PARTS & SERVICE NEWS

REF NO. AT04196

SUBJECT:	REPAIR PROCEDURE FOR LIGHTING SWITCH
PURPOSE:	To inform Field Personnel
APPLICATION:	HD465-7 Trucks, S/N 7001 and up HD605-7 Trucks, S/N 7001 and up HM300-1 Trucks, S/N 1001 and up HM400-1 Trucks, S/N 1001 and up
FAILURE CODE:	DDH1FQ
DESCRIPTION:

1. Details of the modification

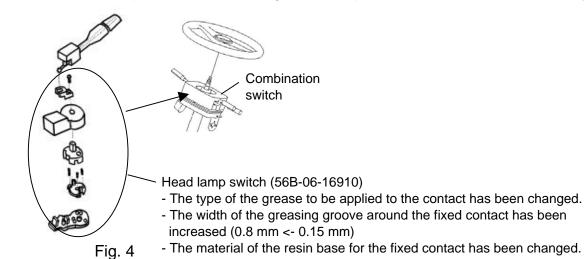
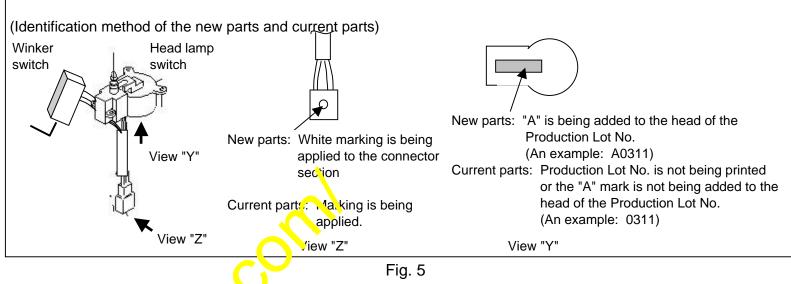
1) The head lamp switch is to be changed to an improved one with increased durability.

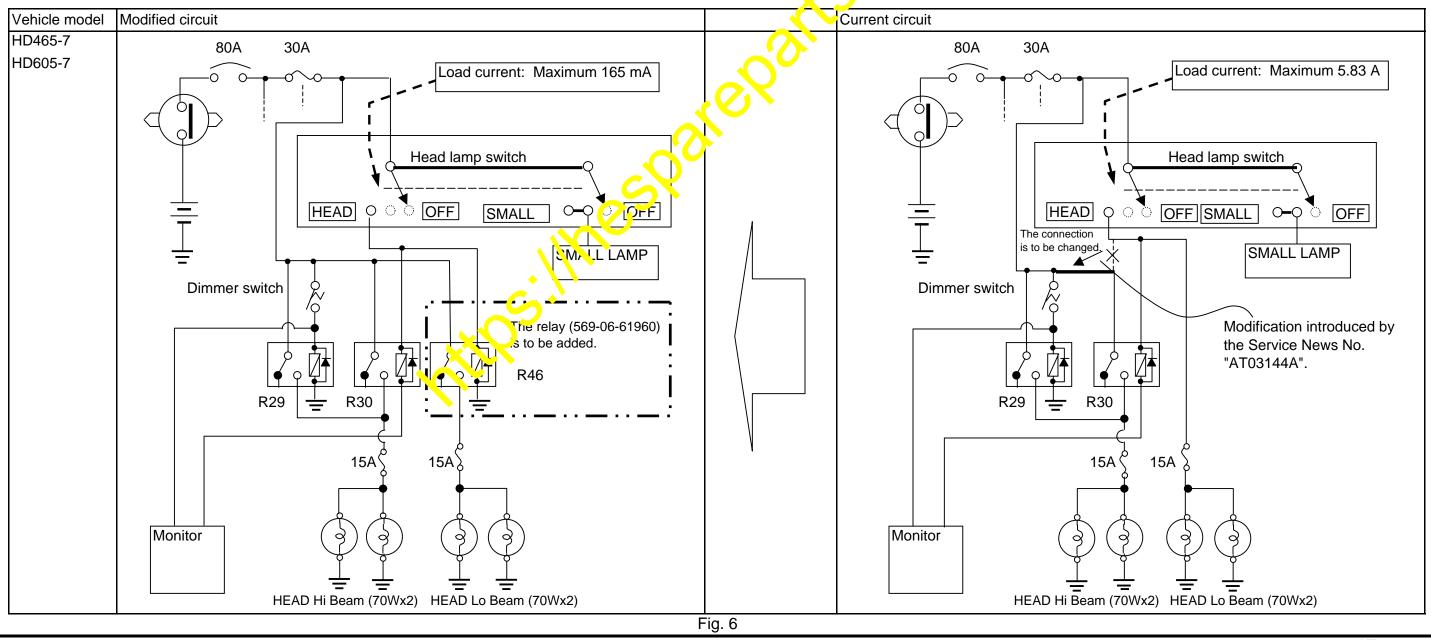
2) Since the current capacity of the head lamp switch is insufficient, the head lamp circuit is to be modified to reduce the electric current flowing through the contact. (Refer to the circuit diagram shown below for details.)
